Seabrook Station

Response to Seabrook Station, Unit No.1 – Supplemental Information Needed for Acceptance of Requested Licensing Action Re: Amendment to Delete Operator Action and Request for Exemption

**ENCLOSURE TO SBK-L-17202**

FIGURE 1

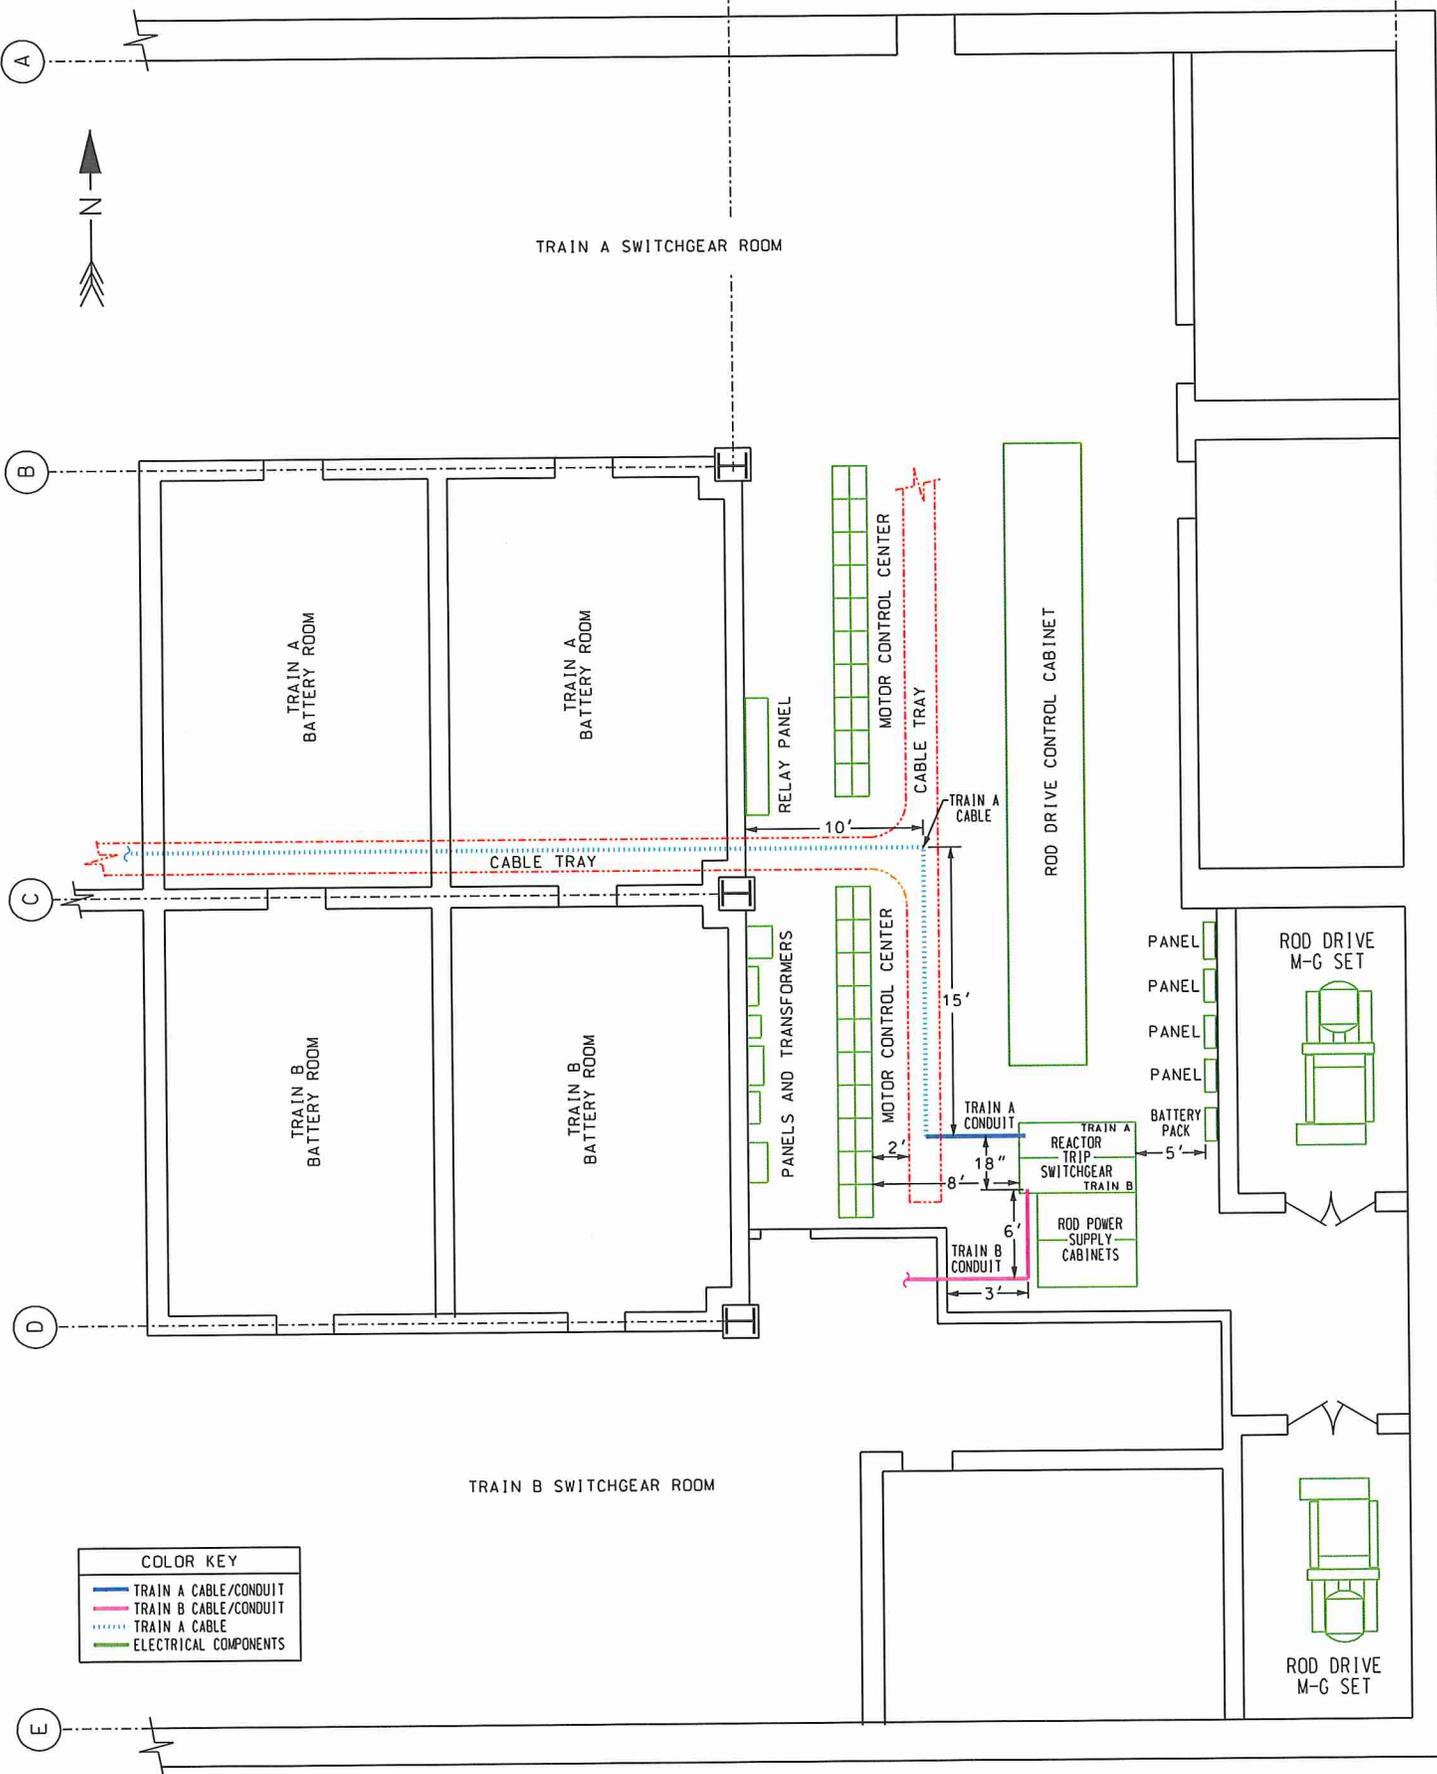
The staff noted that the submittal lacks a discussion of the routing of the shunt trip cables. A better understanding of the room layout, a description of the types of electrical cabinets, and their relationship to the target cabinets and cables is needed for the staff to make a safety determination regarding the lack of 20 feet of separation with intervening combustibles. The staff noted that the submittal also lacks information regarding the relationship between the two trains, and how close the cables are together both vertically and horizontally.

The train A and train B reactor trip breakers are located in adjacent cubicles in the train A switchgear room with the train A breakers north of the train B breakers. The train B switchgear room is located directly south of the train A switchgear room, separated by a 3-hour fire barrier.

The train A shunt trip cables are routed in conduit into a train A cable tray above the reactor trip switchgear train A cabinet about 4 ft. vertical and then 6 ft. west. The cables are routed north in the tray approximately 15 ft. before turning west approximately 10 ft. and over the train A vital battery rooms. The cables continue in the train A cable tray system vertical into the cable spreading room on the control building 50 ft. elevation. The train B shunt trip cables are routed in conduit vertical out of the top of the reactor trip switchgear train B cabinet approximately 20 ft. and then turn south approximately 6 ft. to the wall. The cables then turn west approximately 3 ft. into the train B switchgear room.

The minimum separation distance between the train A and train B cables is approximately 18 inches out of the reactor trip switchgear cabinets for approximately 4 ft. At that point, the train A cables are routed west into the cable tray, and the train B cables continue vertical. There is an Appendix R light battery pack and motor control center, as well as, the transformers and panels described in the TECH1 response in the vicinity of the train A and train B shunt trip cables. The motor control center is approximately 8 ft. from the reactor trip switchgear cabinets. The train B

conduit is approximately 6 ft. horizontal from the train A cable tray out of the top of the reactor trip switchgear cabinet. There are no intervening combustibles between the train A and train B conduits. The train B reactor trip switchgear is located very close to the train B switchgear room (Fire Area CB-F-1B-A), and the train B cable is routed only a short distance in the train A switchgear room as described in the previous paragraph.

The train A cables routed in cable tray in this area are not routed directly above any 480V or 4.16 kV electrical cabinets, and are maintained approximately 4 ft. vertical and 2 ft. horizontal from the nearby motor control center. The train B cables are in a dedicated conduit not routed over any high energy cabinets other than the reactor trip switchgear.

See Figure 1 on the following page for cable routing and equipment layout diagram.
